Name: Sleep n Aire Expansion - 2482 F Road - Site Plan Review

# REVIEW COMMENTS

TITLE HEADING: Final Plan -  
Sleep-n-aire Expansion

Response to Review Comments

Site Grading Plan - 2482 F Road

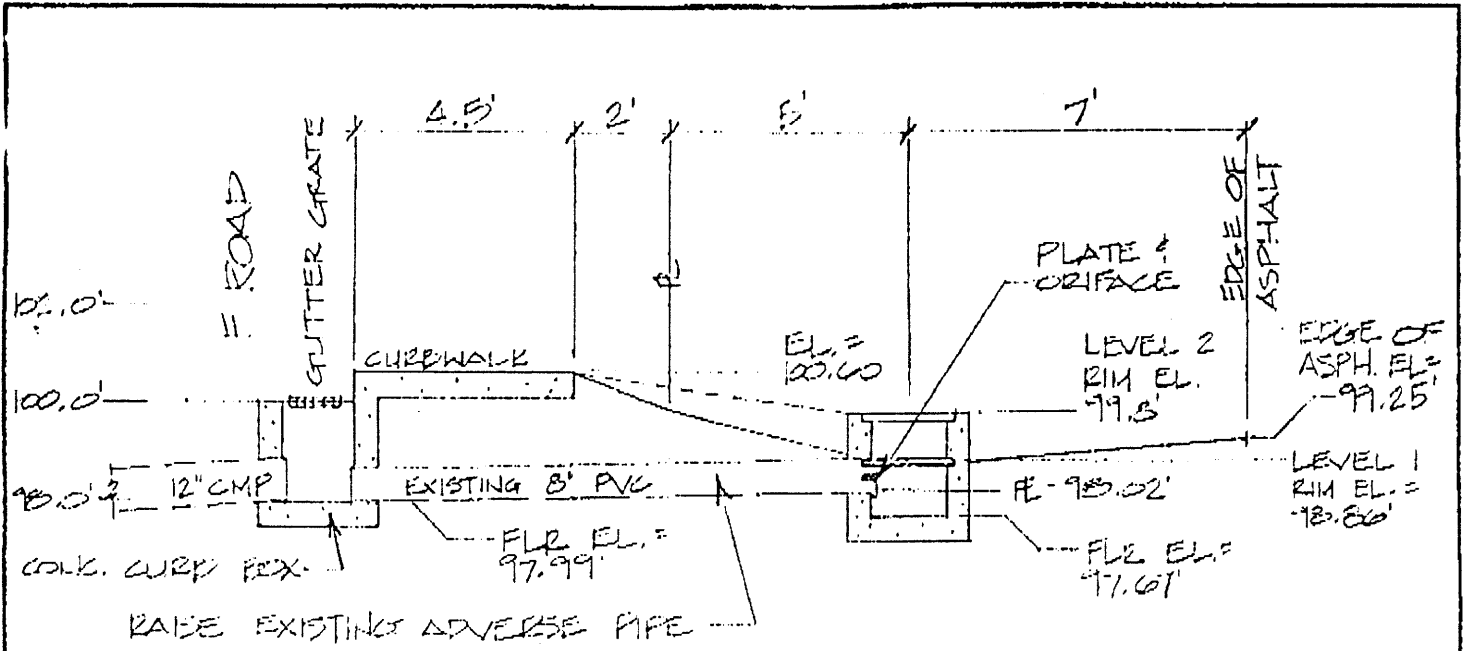
I need the drainage calculations and a detail of the meter outlet.

As designed, the parking area is now constructed as a basin, and will be added to as an addition to the basin. This "basin" is graded to a subsurface pipe outfall system leading to the City drainage system beneath F Road. The pipe system is presently constructed as an 8-inch PVC outlet pipe. It is proposed that this pipe be entered at two levels, with one opening covered by a plate orifice sized for the 2-year flow and the second covered with a plate orifice sized for a 100-year flow minus the existing 2-year flow. The runoff will collect in the parking area and be carried by surface grades to a drop inlet near the sidewalk along F Road, covered with a City Standard "street strength" grated cover, then entering the City sewer system. The volumetric capacity of the parking lot was computed at ascending elevations of 0.2 feet, from the grate at elevation 98.32 to the high point maximum elevation of 100.20 feet. These elevations are based on the existing floor elevation on the site of 101.0 feet.

The required size of the plate orifice to cover the pipe system outfall was found to be a round orifice with a diameter of 2.85 inches. This will provide "historic" discharge at the 2-year runoff level (or less) until water level in the parking lot reaches the critical elevation of 99.8 feet. The second level of the outfall box shall be placed at the elevation of 99.8 feet. A pipe in this section, entering the main outfall pipe, shall be covered with a plate containing an orifice 5.77 inches in diameter. This will allow the 100-year flow from the project site, together with the first orifice described. The double orifice system will maintain runoff from the site to the historic levels between the 2-year and 100-year runoffs.
